APPENDIX 4  
AGENCY COORDINATION LETTERS

We received your e-mail containing a bridge project questionnaire dated November 3, 2008 regarding the necessity of a Coast Guard Bridge Permit on the proposed US 183 Bridge over the Colorado River located in Austin, Travis County, Texas.

### BRIDGE PROJECT QUESTIONNAIRE

Att 3: Plans for Proposed Bridges

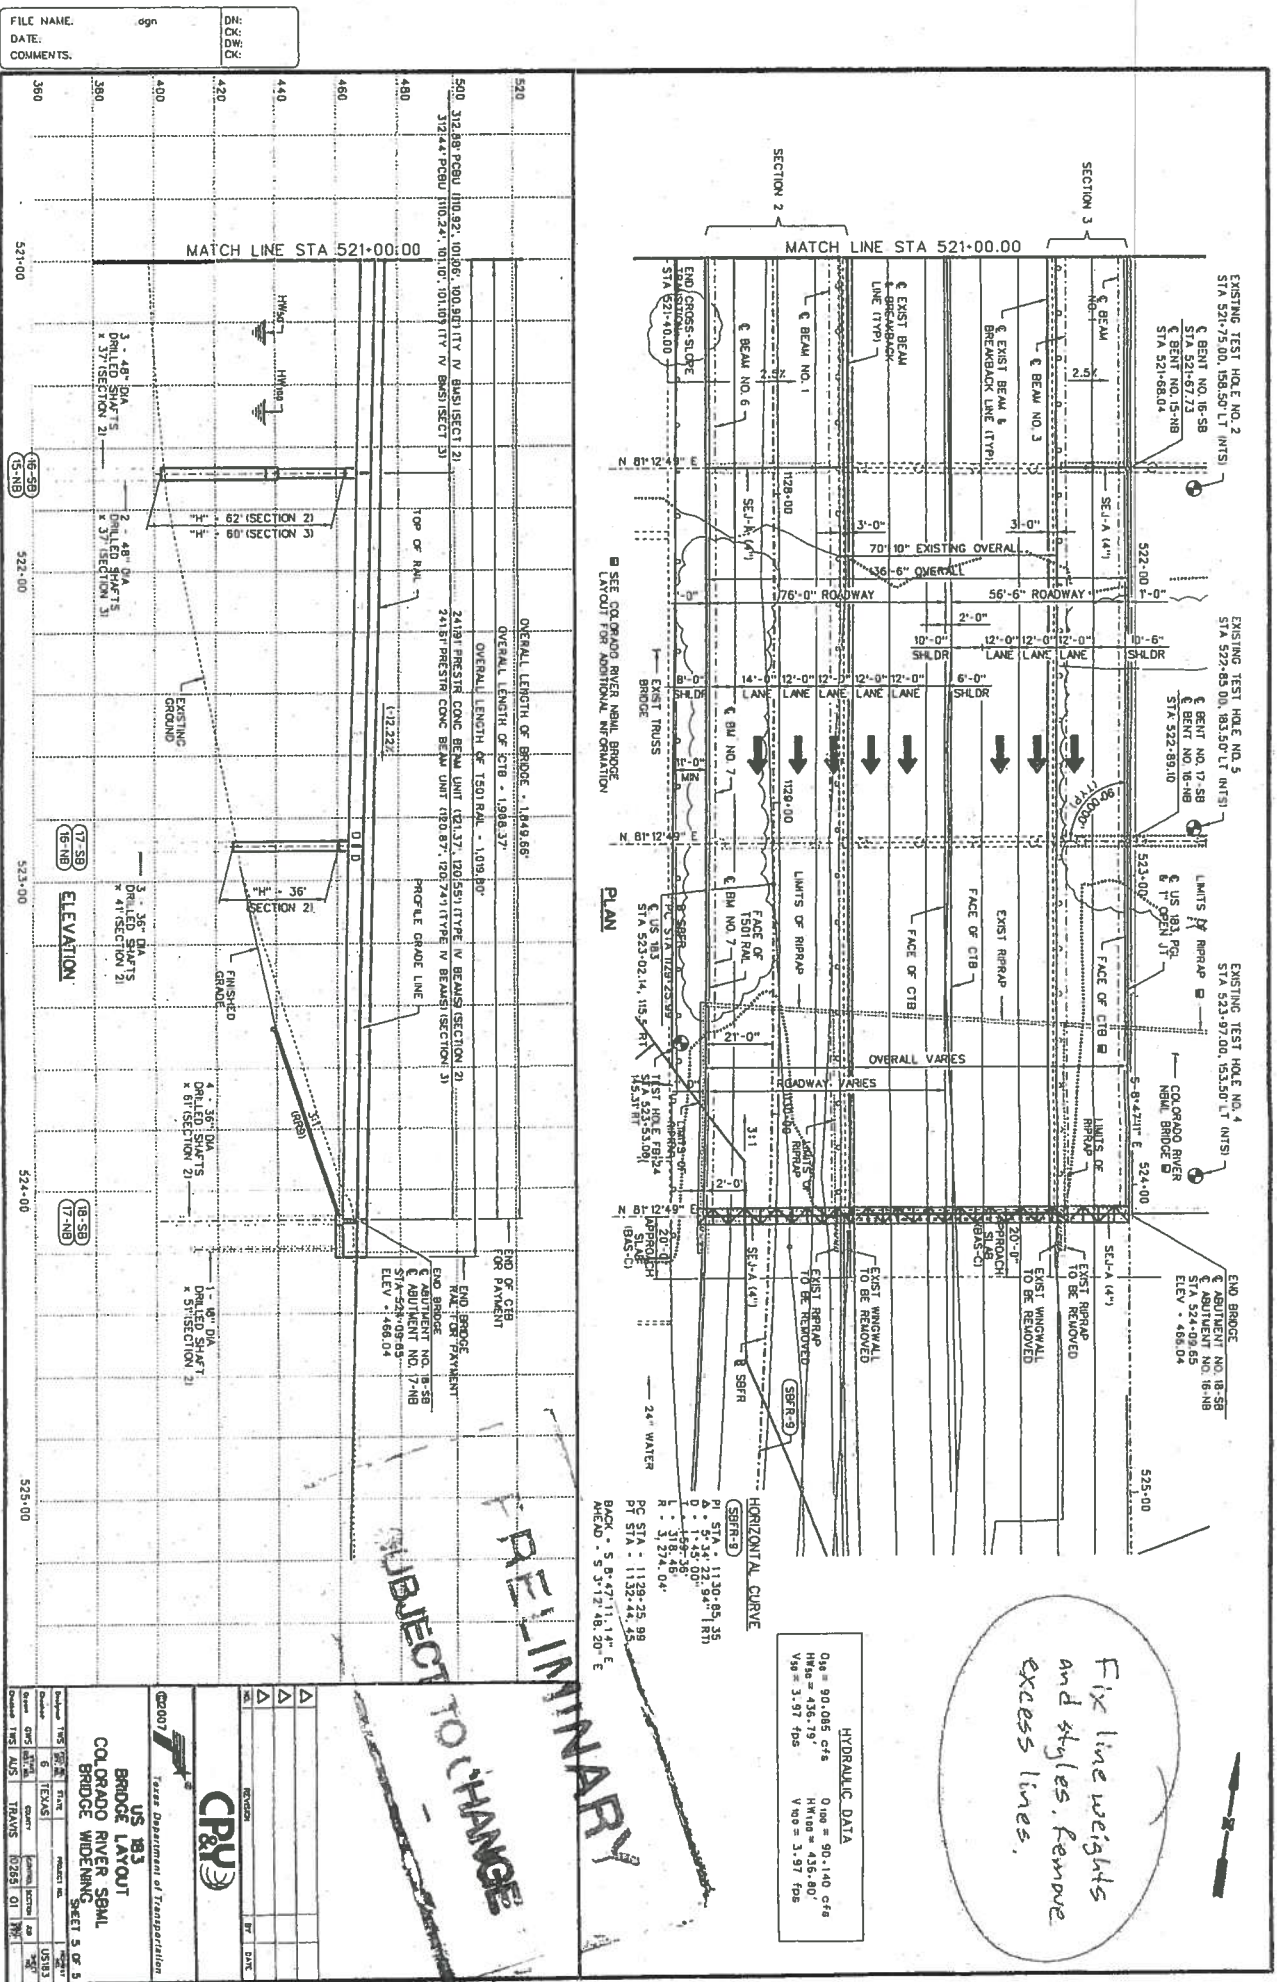
Fix line weights and styles. Remove excess lines.

CP&Y  
 Texas Department of Transportation  
 US 163  
 BRIDGE LAYOUT  
 COLORADO RIVER SBML  
 BRIDGE WIDENING  
 SHEET 4 OF 5

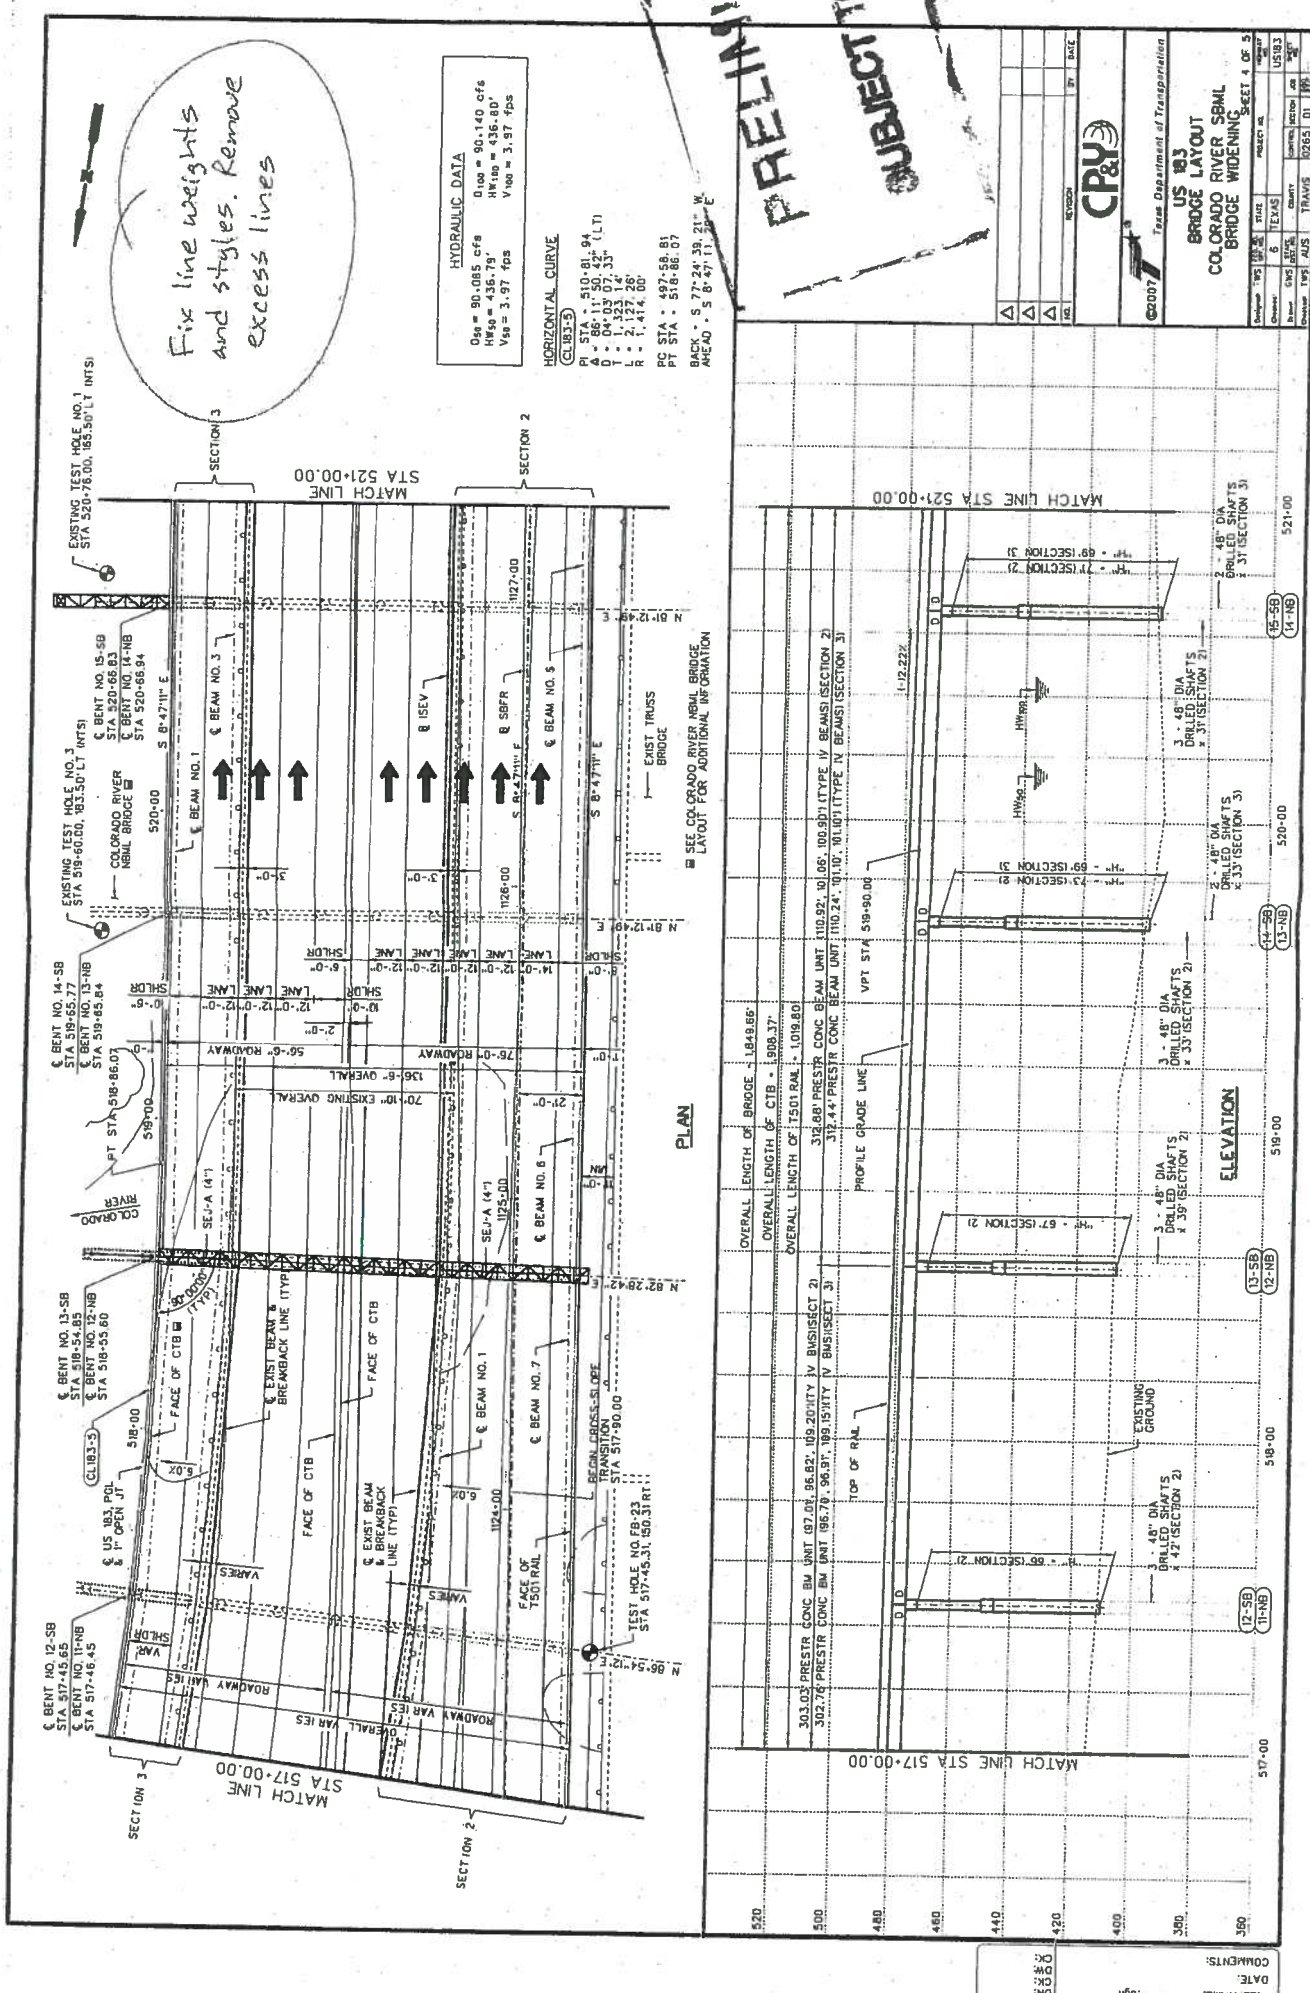
Fix line weights and styles. Remove excess lines

US 1933  
 BRIDGE LAYOUT  
 COLORADO RIVER SBML  
 BRIDGE WIDENING  
 SHEET 3 OF 5

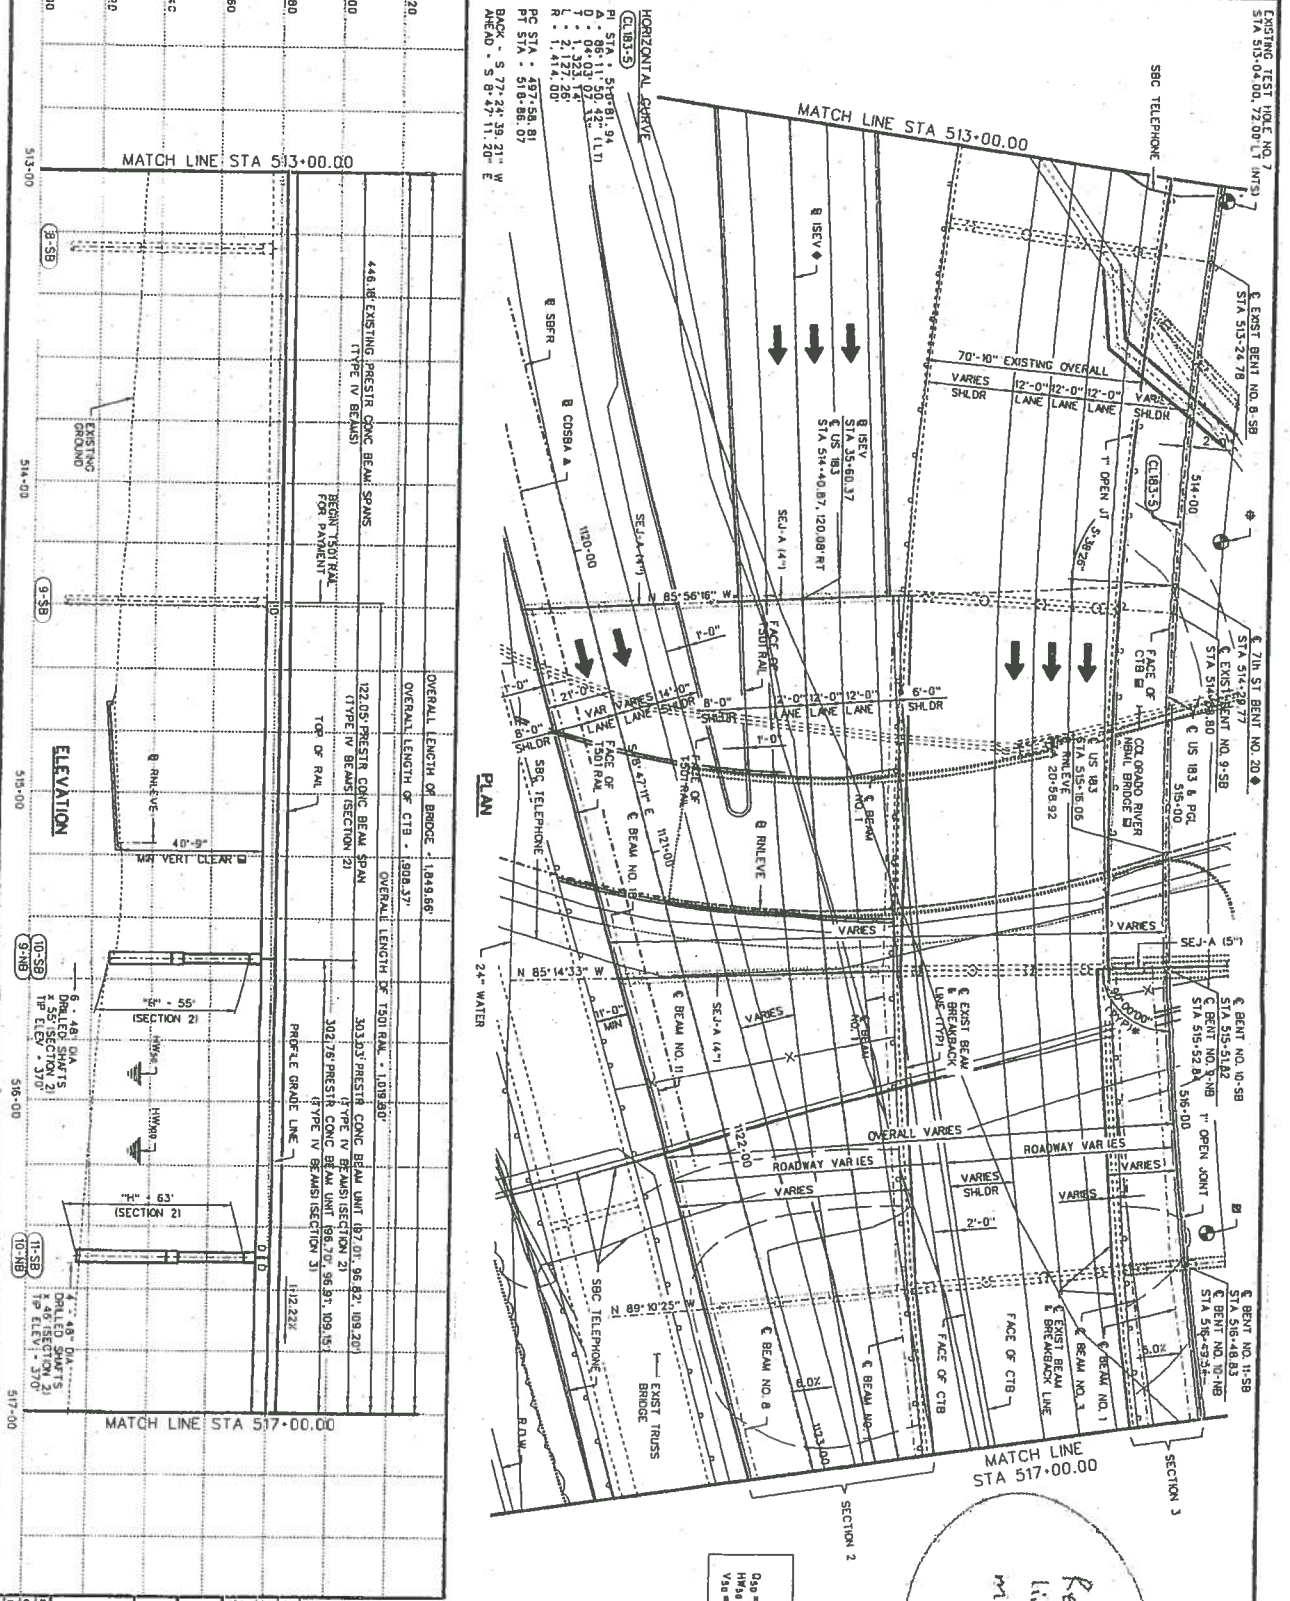
Remove excess lines and add missing lines

Austin 1:125,000 USGS Topographic Quadrangle Surveyed 1895-96

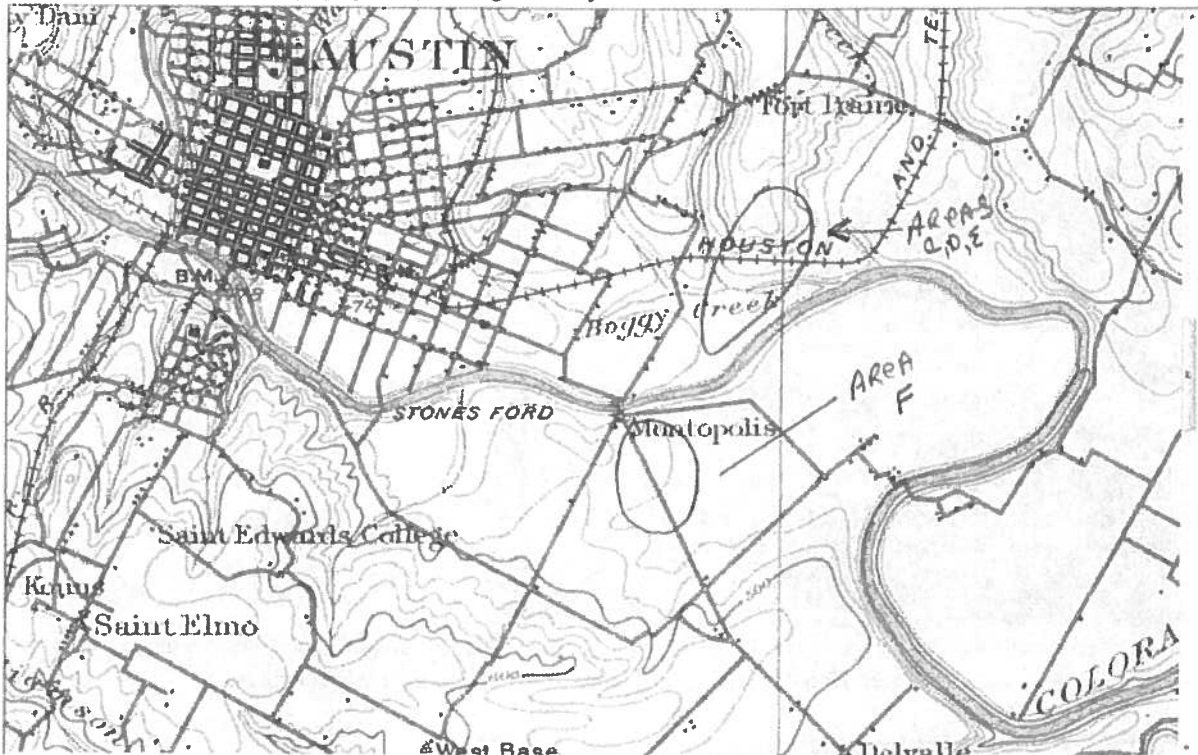
One possible structure  
East of Road @ Base of the M  
in Montopolis. However AREA F  
New Row is West of Road.

Also no structures in AREAS C, D, and E.
